Re: Montague Wind Power Facility Change Request #3 – Proposed Site Boundary and Transmission Line Route Modifications

Supplement to Change Request #3

Figure 1
Montague Proposed Modifications to
Approved Site Boundary and
230-kV Transmission Line Corridor
Montague Wind Power Facility -
Change Request #3

Figure 6
Rare Plants
Montague Wind Power Facility -
Change Request #3

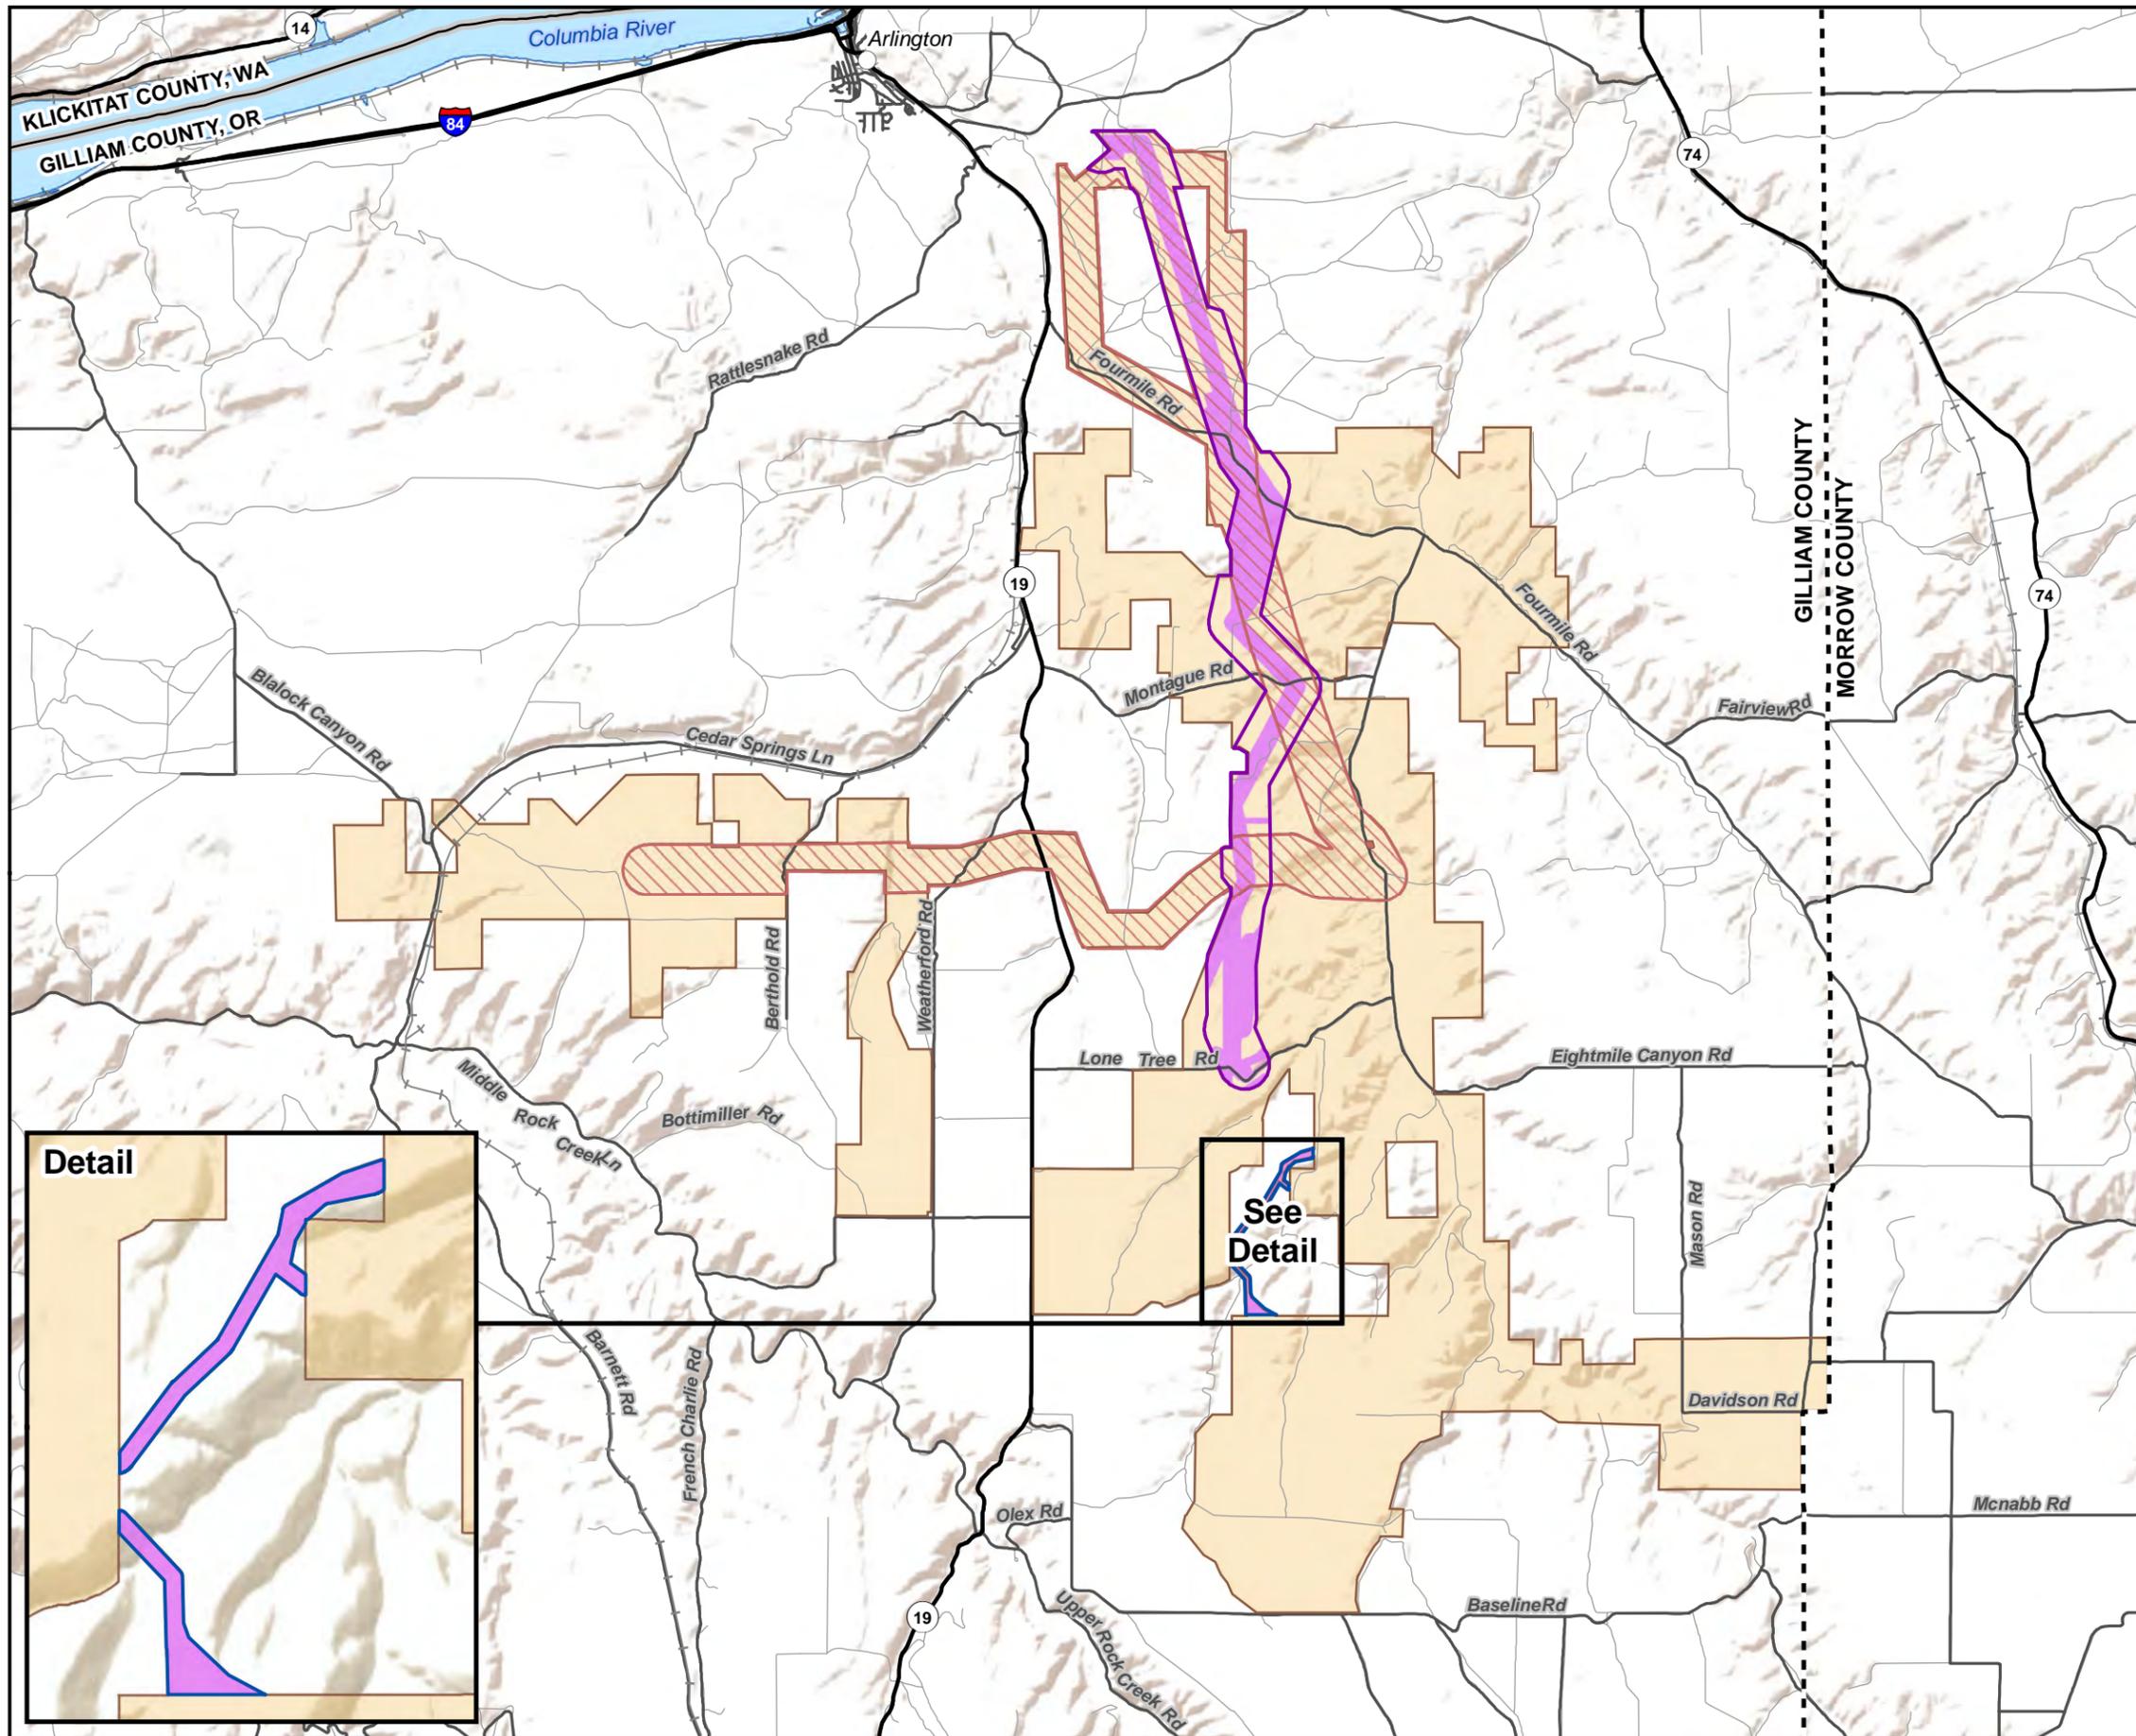
- A focused botanical field investigation was conducted in Spring 2017 at the Facility. Figure 6 shows the 2017 survey areas that correspond to the proposed modifications. Areas within the site boundary that are planted in wheat or other crops do not provide suitable habitat for rare plants. During field surveys, these areas were verified to be planted in crops and were not surveyed further. A written report of results of the field investigation, submitted to ODOE as part of Montague's preconstruction compliance (CH2M, 2017a), demonstrates that no rare plant species were found within the areas that will be impacted by Facility construction.

Figure 7
Washington Ground Squirrel
Montague Wind Power Facility -
Change Request #3

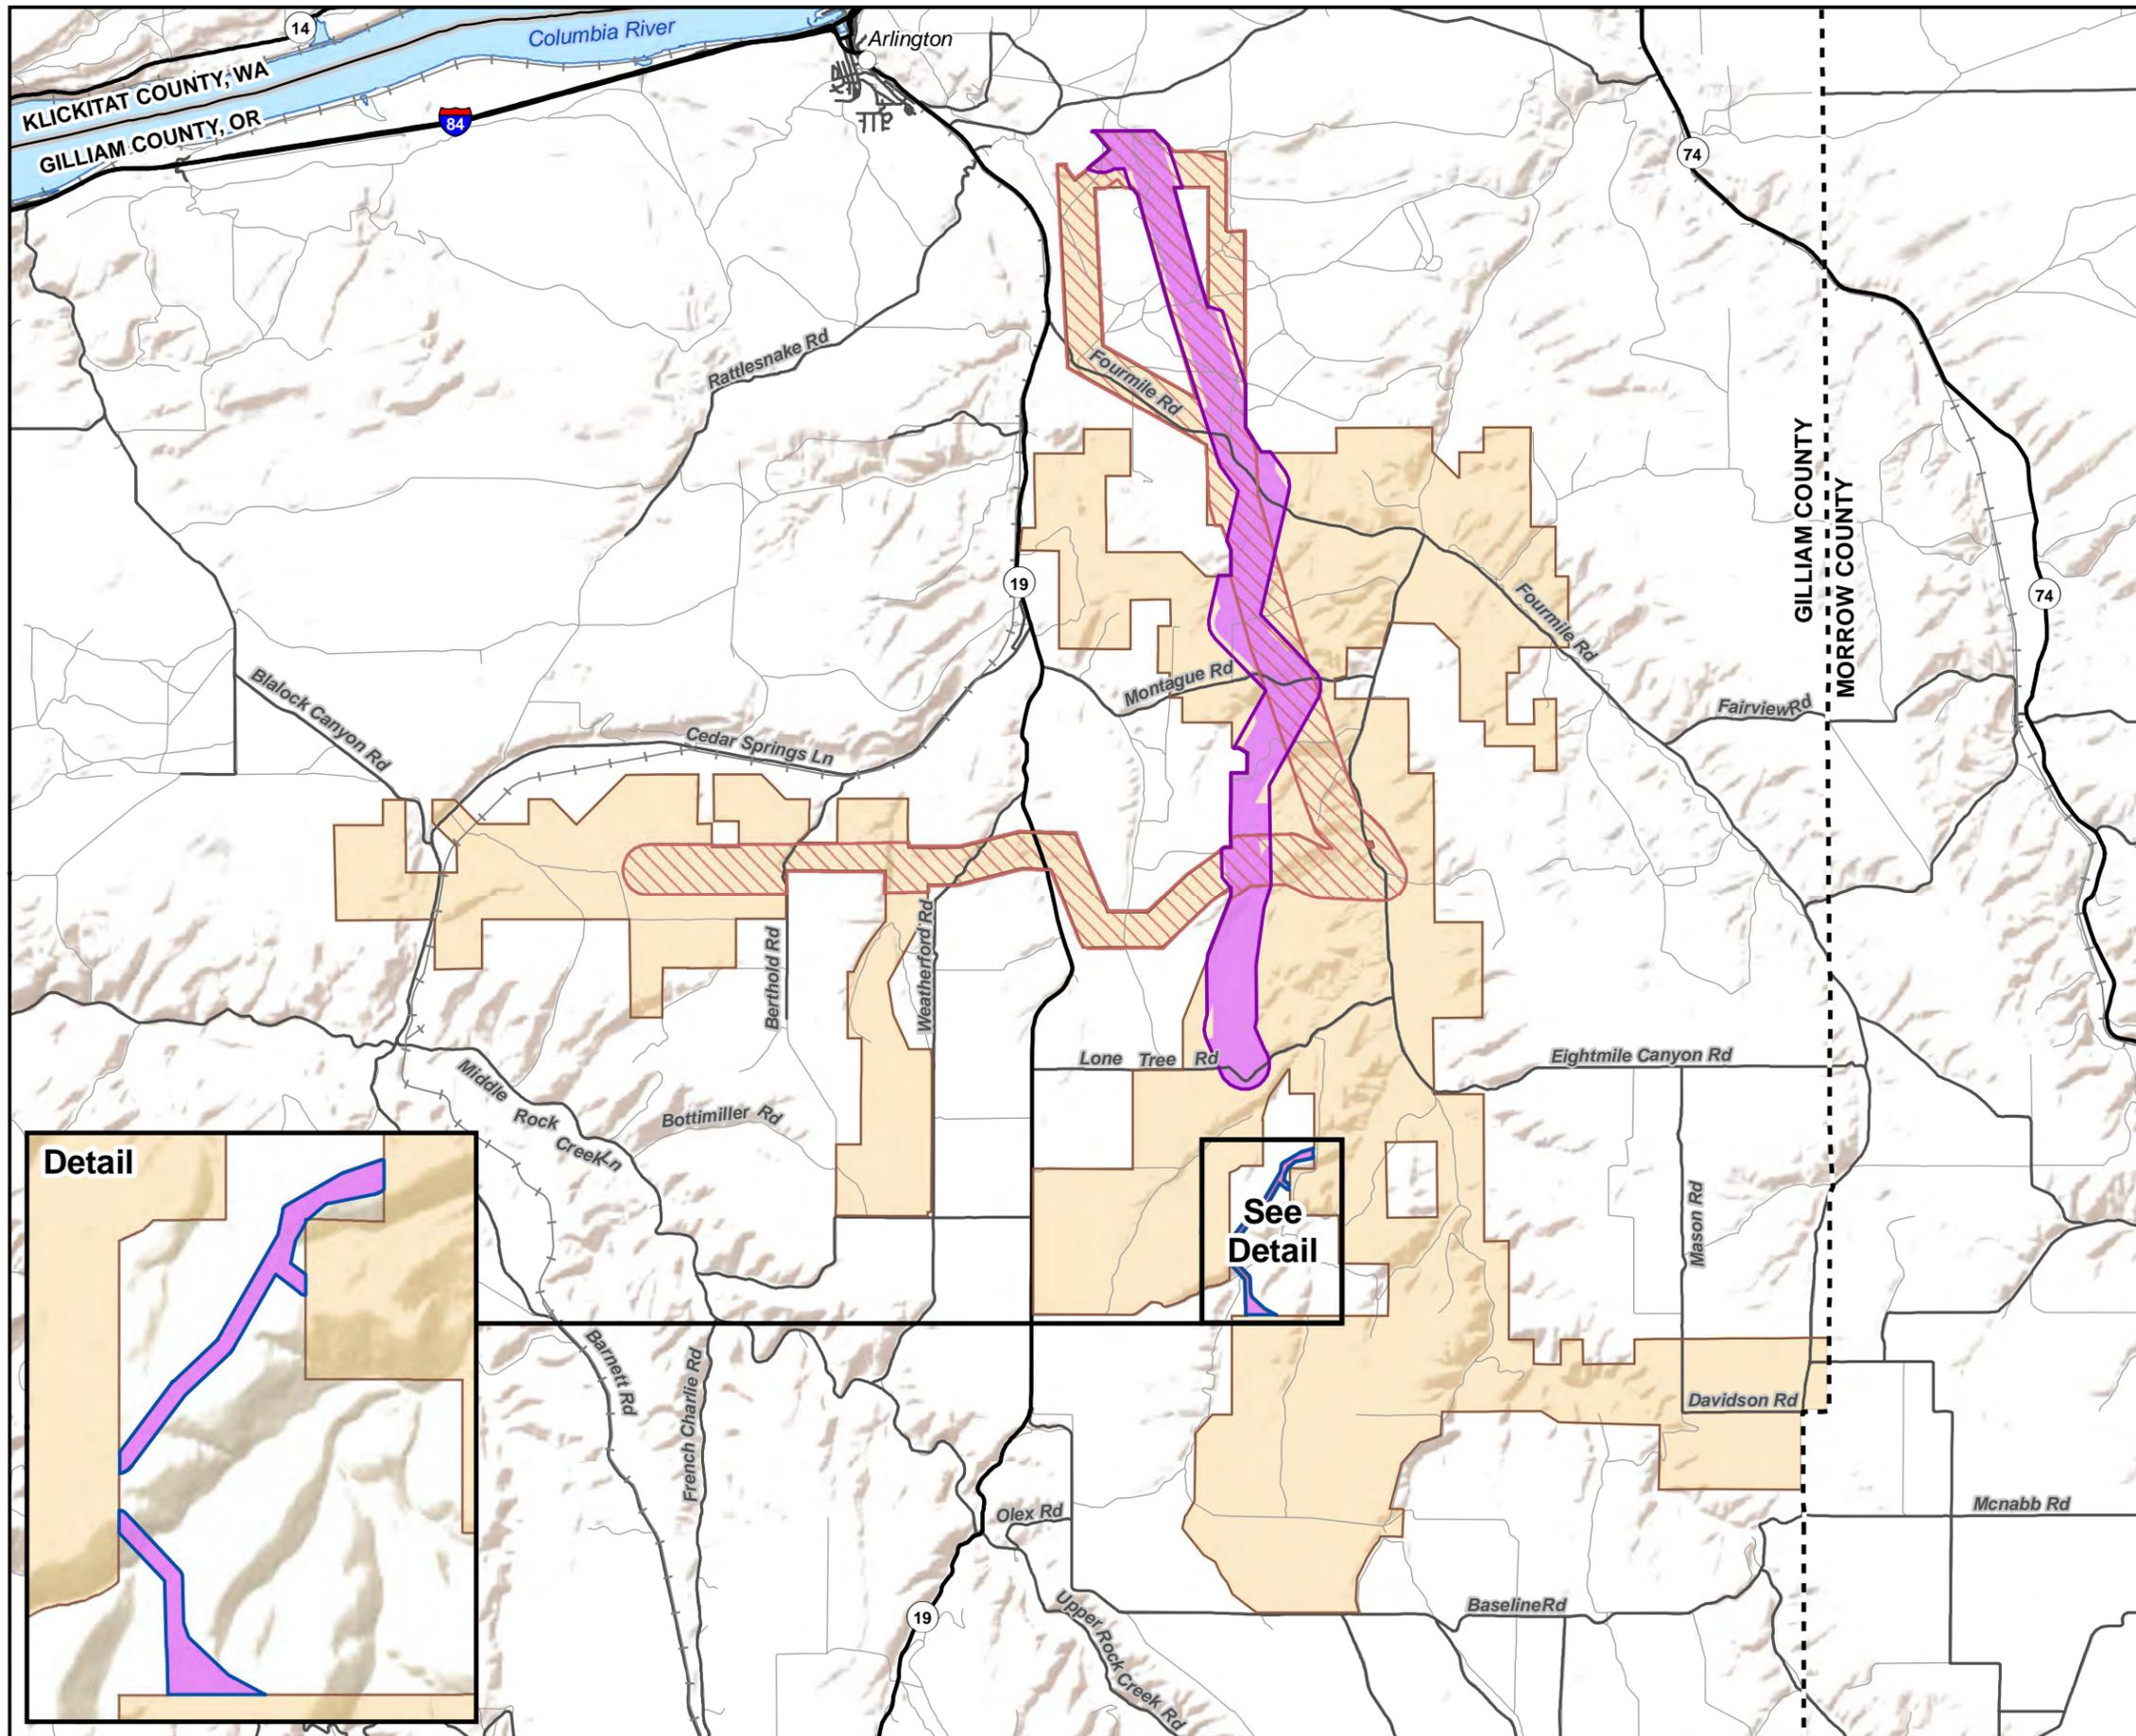
- WGS protocol surveys and associated Category 1 habitat mapping were conducted in the spring of 2017 at the Facility in compliance with Condition 94(c) (CH2M, 2017b). Figure 7 shows the 2017 WGS survey areas including the areas covered by this change request.

- In accordance with ODFW-approved survey protocols and habitat guidance, Category 1 habitat was mapped on nonagricultural land within 785 feet of identified WGS burrows. The proposed Facility components were designed to avoid Category 1 habitat. Additionally, most of the components described in this change request are sited in Category 6 habitat that is not suitable for WGS (e.g., wheat fields).

Figure 1: Proposed Modifications to Approved Site Boundary and 230 kV Transmission Line Corridor

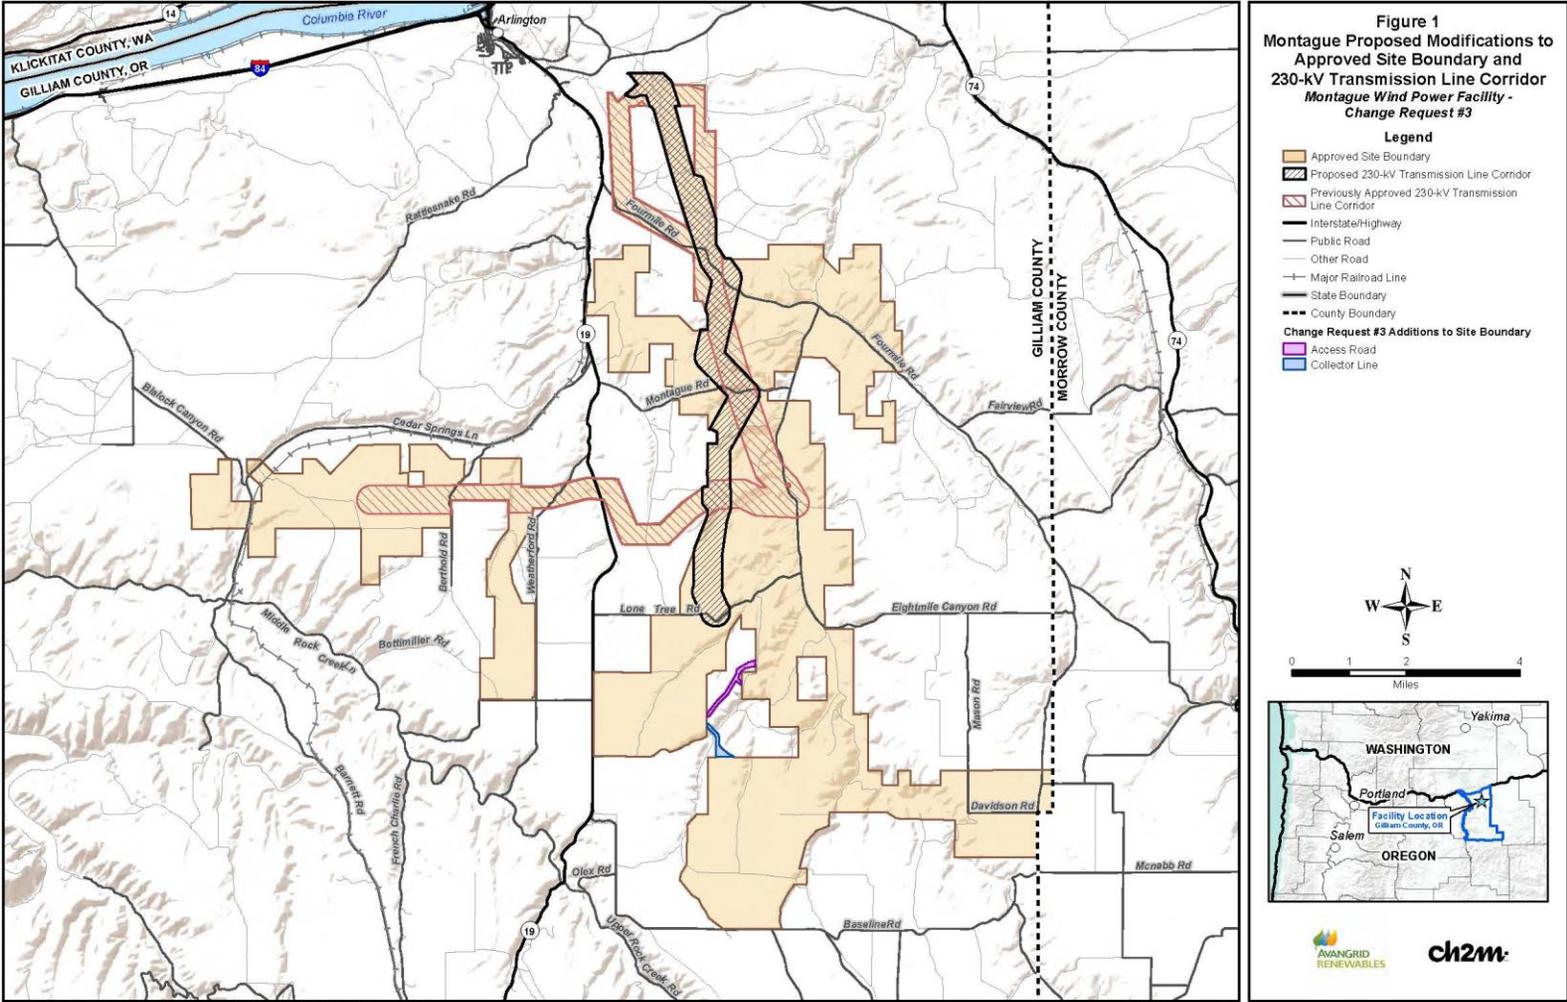
The certificate holder proposes to add approximately 91.8 acres to the facility's site boundary to authorize construction and operation of two segments of permanent access road and above- and below-ground collector lines (referred to as "proposed site boundary additions"). The access road segments would extend approximately 1-mile in total, and collector lines would include 4,224-linear feet of above- and below ground segments. The access road would be 80-feet wide during construction to provide adequate transport paths for crane operation. The permanent road would be approximately 20-feet in width; the area impacted during construction from the crane path would be restored following completion of construction. As shown on Figure 1 (see below), the proposed access road and collector line segments would cross an area previously excluded from the site boundary because, as described in the change request, the land was previously under lease control by a different developer. The certificate holder acquired the rights to this land, and as shown on Figure 1, the proposed access road and collector line routes would provide more direct access to facility components and would avoid the need for construction on geographically constrained areas containing steep slope and hillside.

The transmission line route/corridor must be changed to avoid Category 1 WGS habitat identified during 2017 pre-construction surveys. The proposed modified transmission line route/corridor would be located entirely within the previously-approved facility site boundary and the total linear length would be reduced from 19- to 10.5 miles, reduce the linear facility routing options from 3 to 1, and would change the corridor location as represented on Figure 1 (see below). The certificate holder requests that the transmission line corridor extend the length of the 10.5-mile transmission line route, and extend ½-mile in width consistent with the OAR 345-001-0010(13) definition of "corridor."
